# Application for Certification (15-AFC-01)

**Puente Power Project (P3)**  
Oxnard, CA

**Responses to CEC Data Requests Set 4 (77-107)**

**FIGURE 105-1**

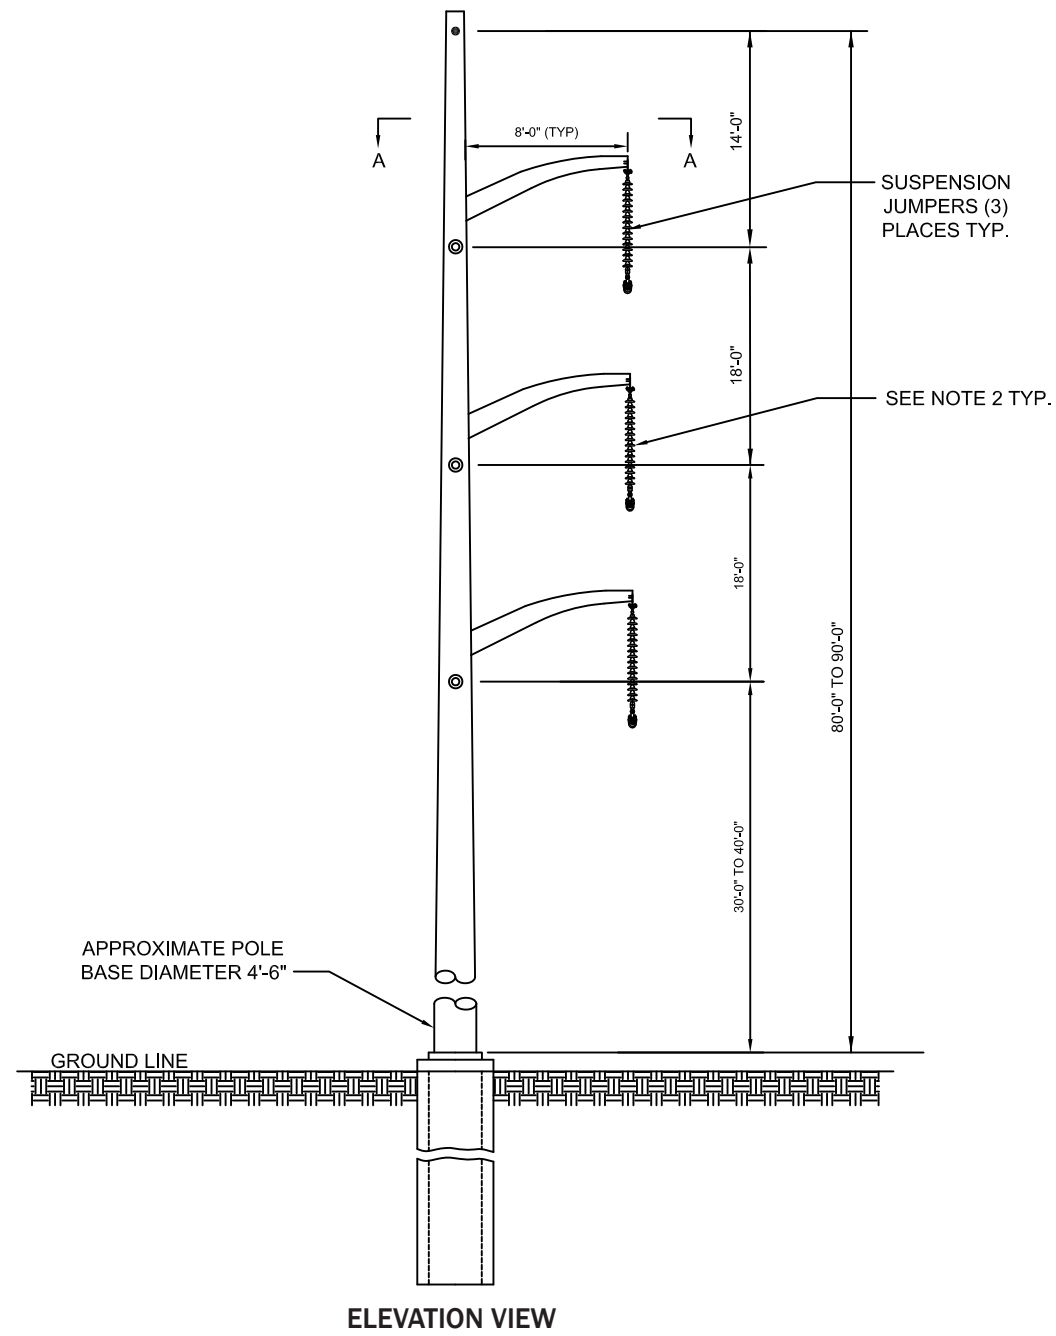
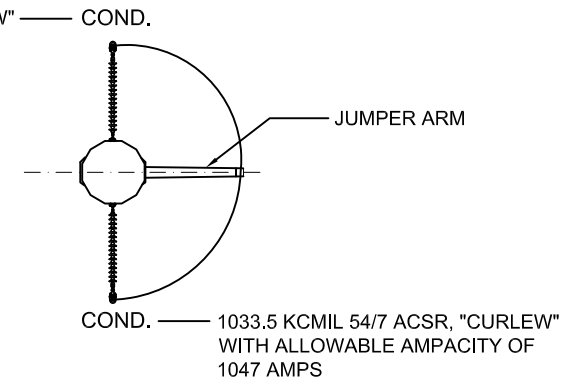
- 105. Provide the details for and modifications to the substation or tower equipment necessary for the project interconnection. Provide proposed ratings for this equipment.**

Figure 105-1 shows the double-circuit structure outline, and Figure 105-2 shows the single-circuit structure outlines. The figures show the details for materials and equipment ratings.
